**FPL Energy**  
**Seabrook Station**

Seabrook Station  
Response to Request for Additional Information Regarding  
License Amendment Request 04-03, Application for Stretch Power Uprate

**Enclosure 1 to Letter No. SBK-L-04072  
Response To Request for Additional Information  
for LAR 04-03, Application for Stretch Power Uprate  
(Non-Proprietary)**

**FIGURE RAI 37-1**  
**Peak Cladding Temperatures**

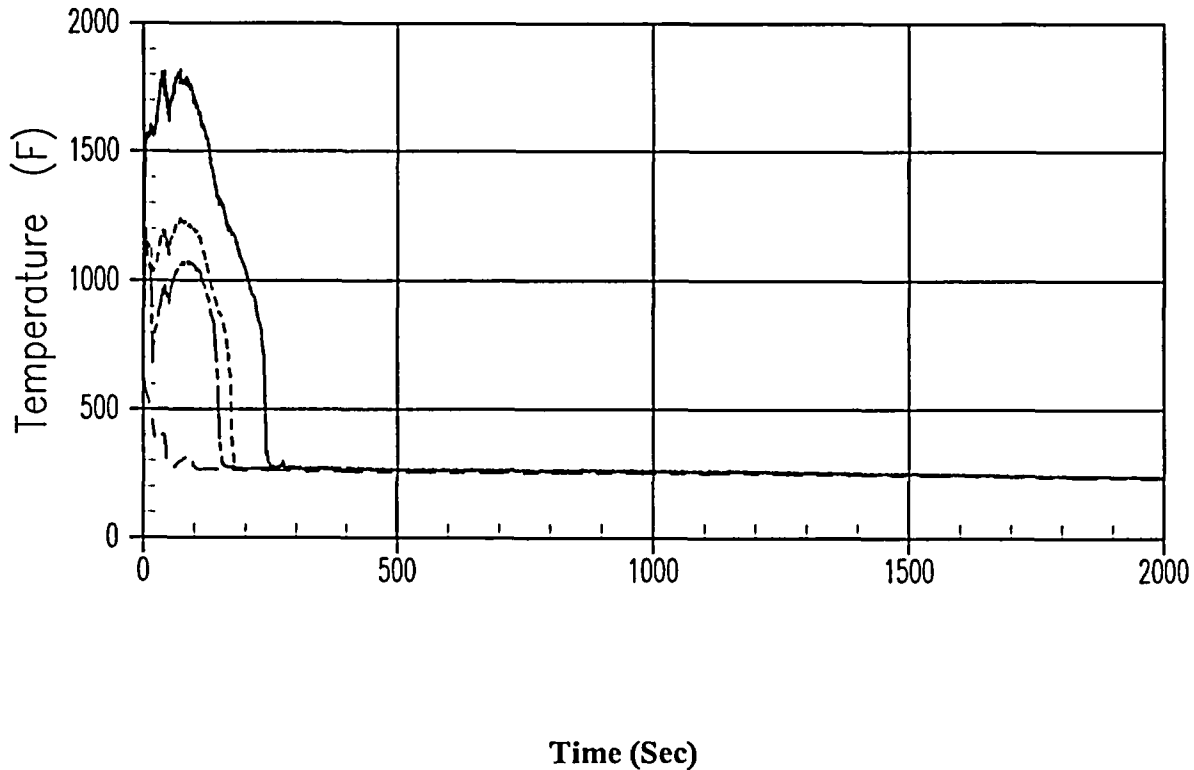
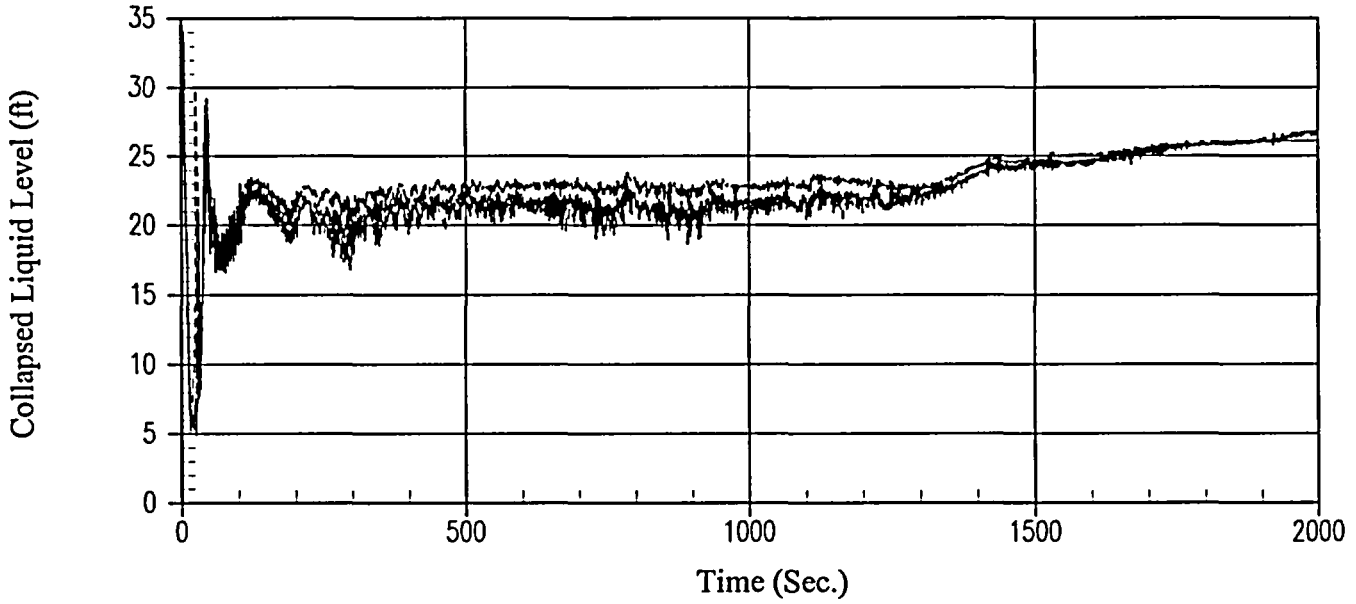
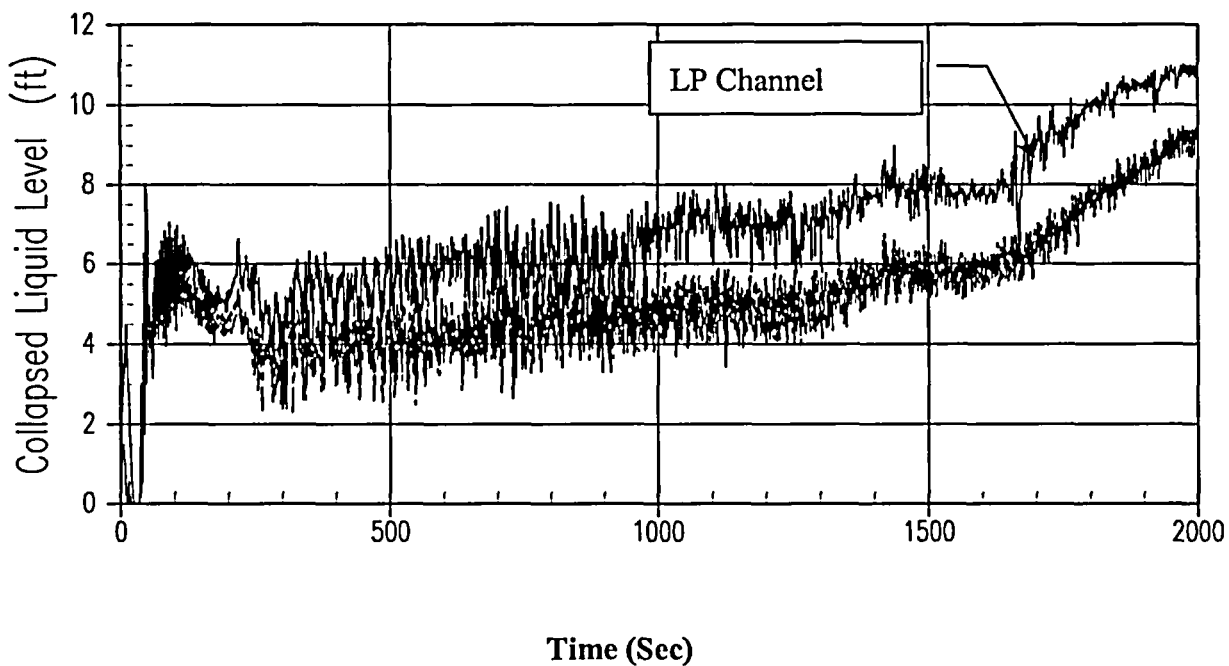
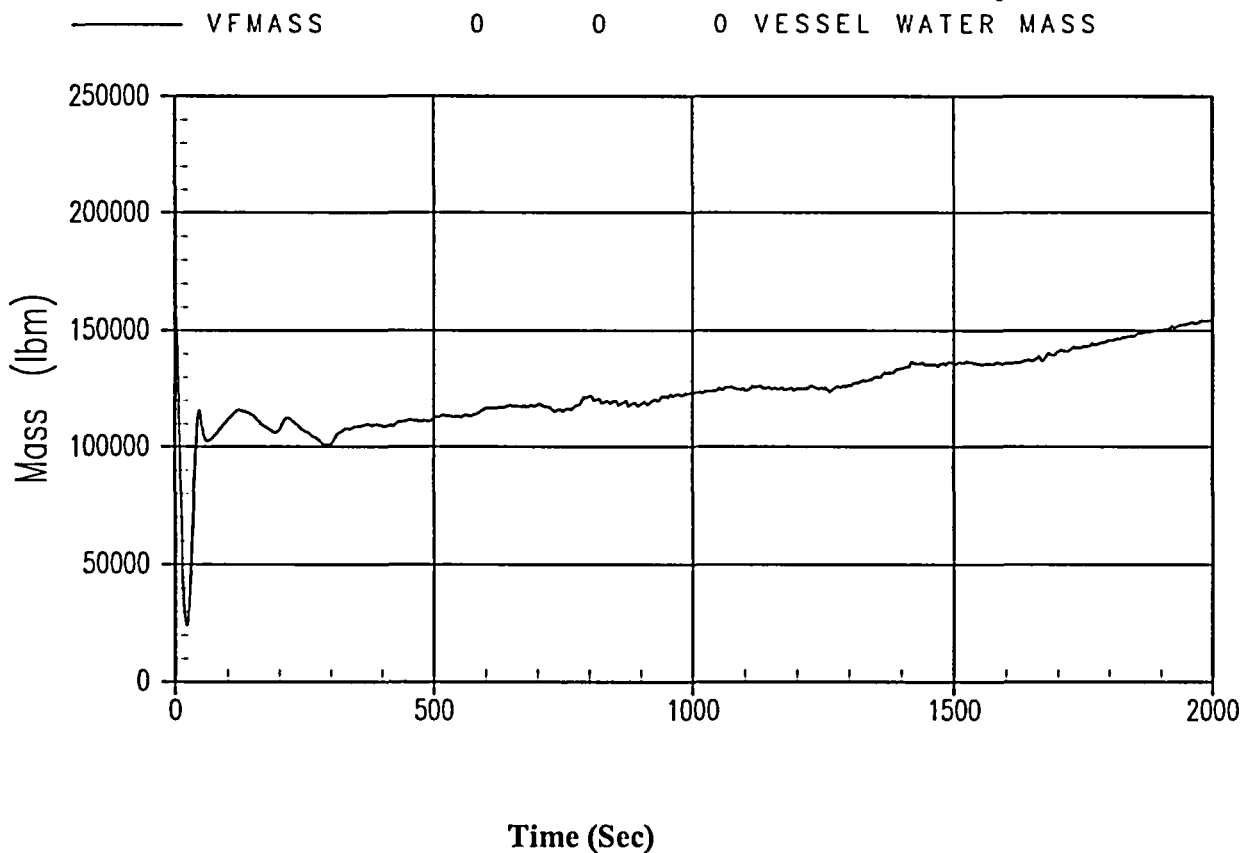
Provide the LBLOCA analysis results via tables and graphs to the time that stable and sustained quench is established.

In order to demonstrate stable and sustained quench, the WCOBRA/TRAC calculation for the maximum local oxidation analysis for Seabrook Station was extended. Figure RAI 37-1 shows the peak cladding temperatures for the five rods modeled in WCOBRA/TRAC. This figure indicates that quench occurs at approximately 100 seconds for the low power rod (rod 5), 175 seconds for the core average rods (rods 3 and 4), and around 250 seconds for the hot rod (rod 1) and hot assembly average rod (rod 2). Once quench is predicted to occur, the rod temperatures remain slightly above the fluid saturation temperature for the remainder of the simulation. Figure RAI 37-2 shows the collapsed liquid level in the four downcomer channels and shows steady behavior, with the level in each quadrant remaining near the bottom of the cold leg. By 1400 seconds, bulk boiling in the downcomer has been terminated, and subcooling in the downcomer has been re-established. Figure RAI 37-3 shows the collapsed liquid level in the four core channels and indicates a gradual increase in the core liquid inventory. This is consistent with the expected result based on the removal of the initial core stored energy and the gradual reduction in decay heat. Figure RAI 37-4 shows the vessel liquid mass and indicates an increasing trend beginning at about 300 seconds. This indicates that the increase in inventory due to the pumped safety injection is more than offsetting the loss of inventory through the break. Based on these results, it is concluded that stable and sustained quench has been established for the Seabrook Station Large Break LOCA analysis.

**FIGURE RAI 59-1  
LOSS OF NONEMERGENCY AC POWER TO THE PLANT AUXILIARIES  
PRESSURIZER PRESSURE – CASE COMPARISON**

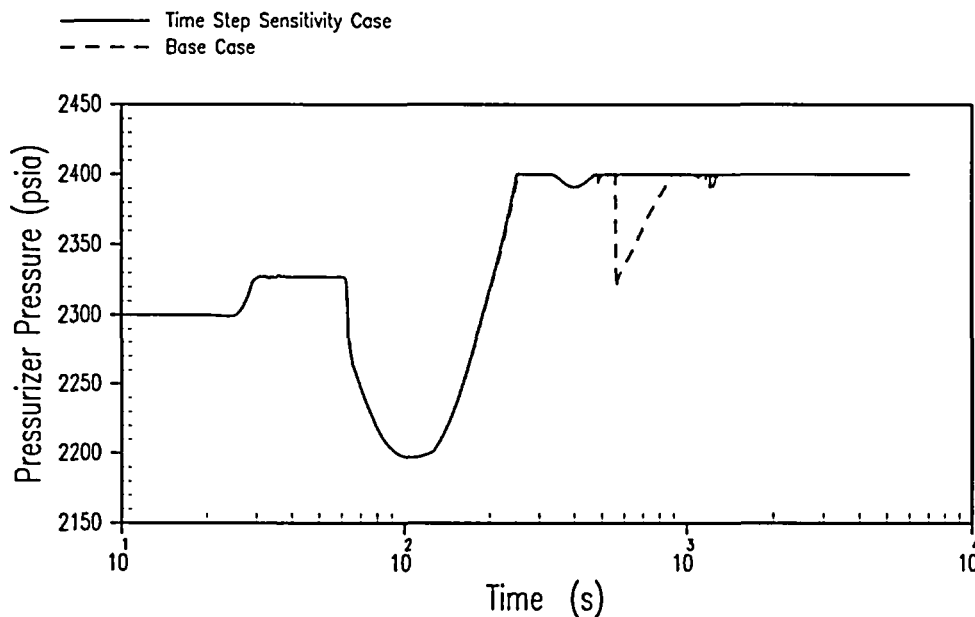
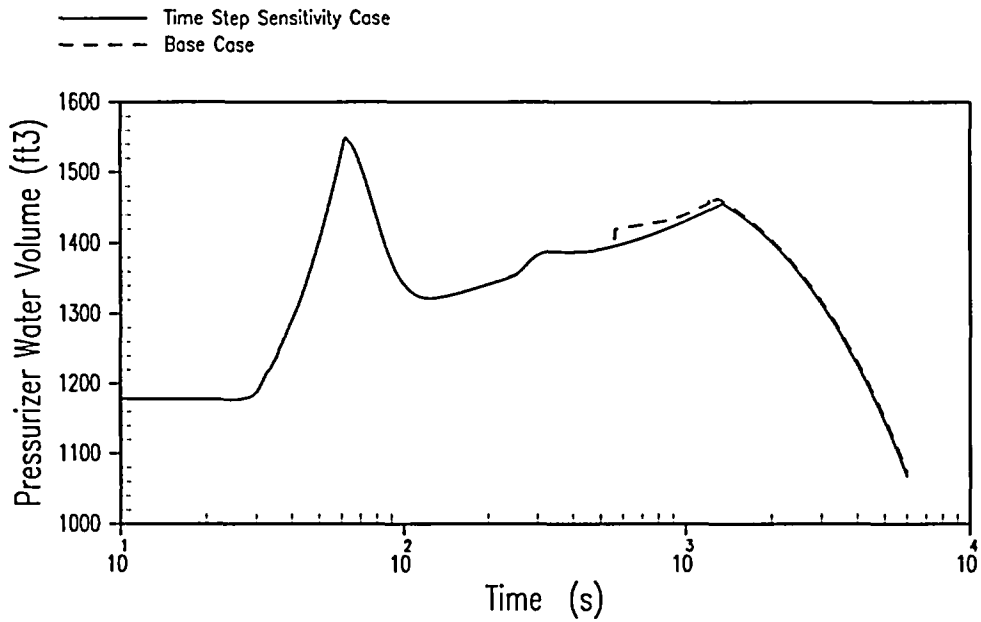
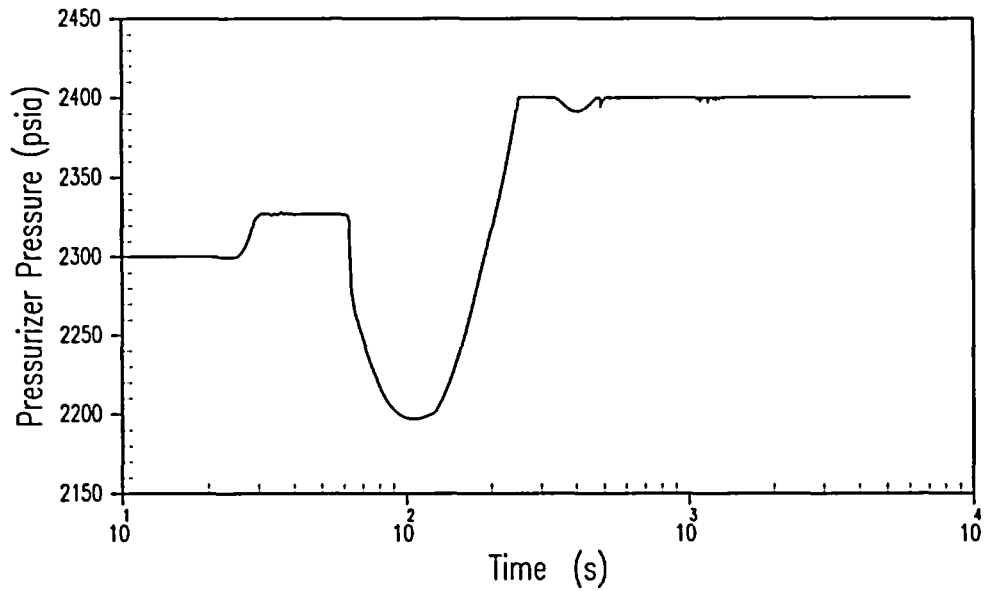
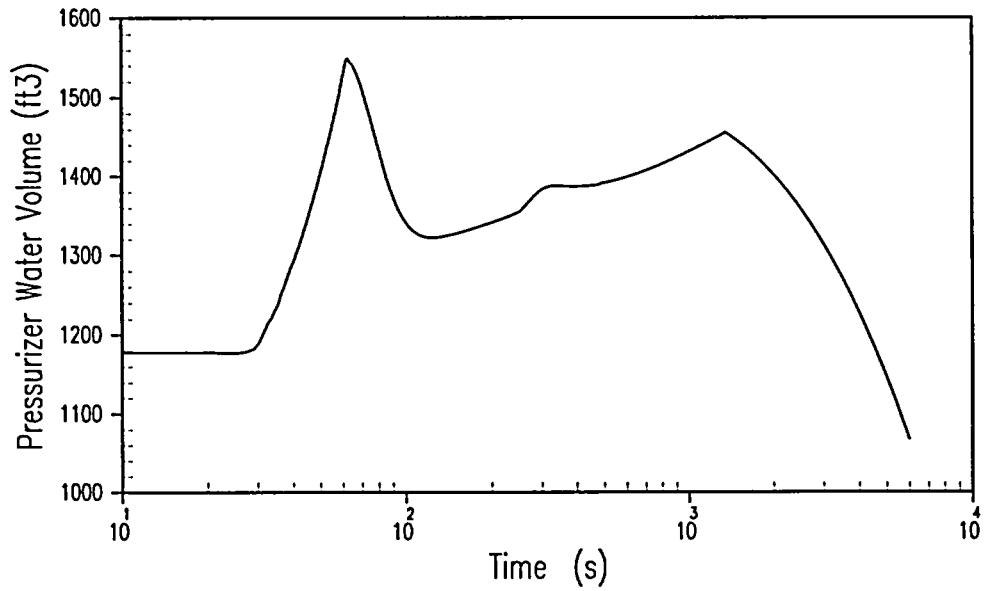
Explain the drop in pressurizer pressure, occurring at about 10 minutes in Figure 6.3.3.3-3.

The apparent drop in pressurizer pressure shown on the figure at ~600 seconds is not a real phenomenon, but is an anomalous result of the time step selected in the RETRAN input. This same case was rerun with a slightly smaller maximum time step to evaluate the sensitivity of the results to the time step chosen, and the pressure drop in question did not occur. See Figure RAI 59-1. The pressurizer water volumes for the two cases were compared, and the case presented in the LAR Attachment 1 Subsection 6.3.3.3 (page 6-109) (base case) results in a slightly higher (more conservative) long-term peak value, although the difference is not significant (1463 ft<sup>3</sup> versus 1456 ft<sup>3</sup>). See Figure RAI 59-2. Therefore, although the pressure drop shown in LAR Attachment 1, Figure 6.3.3.3-3 (page 6-146) is not a real phenomenon, it does not have a significant impact on the results of the analysis. Figures RAI 59-3 and RAI 59-4 present the pressurizer pressure and pressurizer water volume plots, respectively, for the slightly less limiting time step sensitivity case.

**FIGURE RAI 62-1  
Seabrook MSLB DER Forward and Reverse Break Flows**

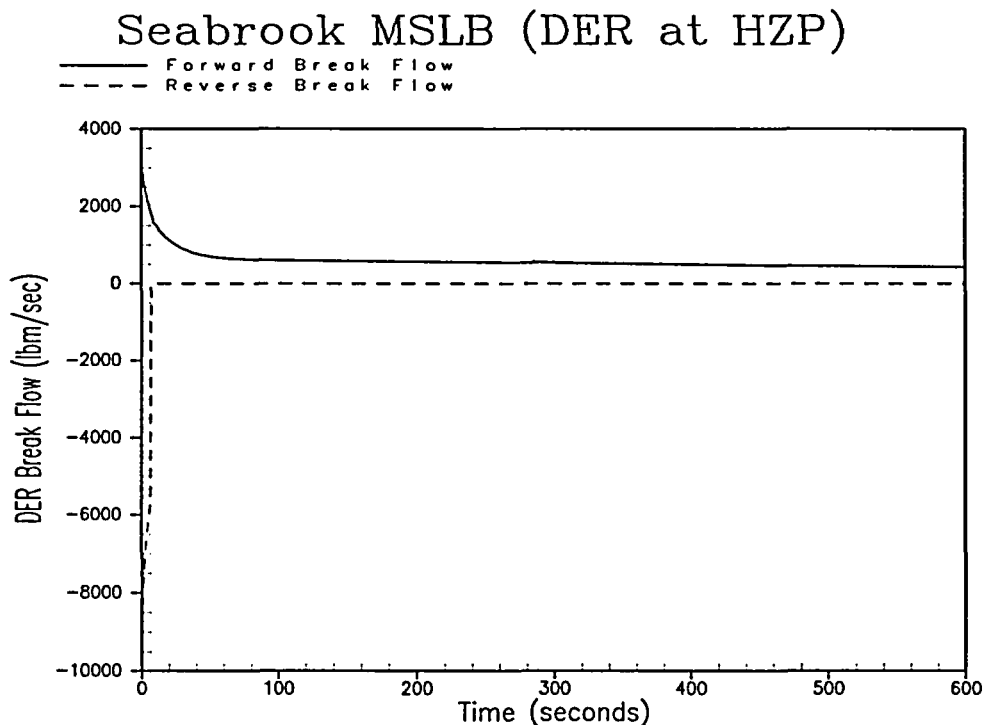
Explain why steam flow in the faulted loop (Figure 6.3.2.4-7), goes to zero at less than ten seconds into the transient. Did the analysis assume that the main steam isolation valve (MSIV) in the faulted loop would fail to close?

The two plots in LAR Attachment 1, Figure 6.3.2.4-7 (page 6-96) reflect the steam flow through the faulted loop's main steam isolation valve and the steam flow through the main steam isolation valve of one of the intact loops. The faulted loop main steam isolation valve flow is negative because it represents the steam flow from the intact loops and the header. The main steam isolation valve closure that occurs 6 seconds after the low steam line pressure setpoint is reached isolates the intact loops and steam header from the break, thus leaving only the faulted loop blowing down. Figure RAI-62-1 provides a plot of the forward and reverse break flows. A failure of the faulted loop main steam isolation valve was not assumed, however, such a failure would only allow the steam header to continue to blow down, which does not affect the Reactor Coolant System transient.
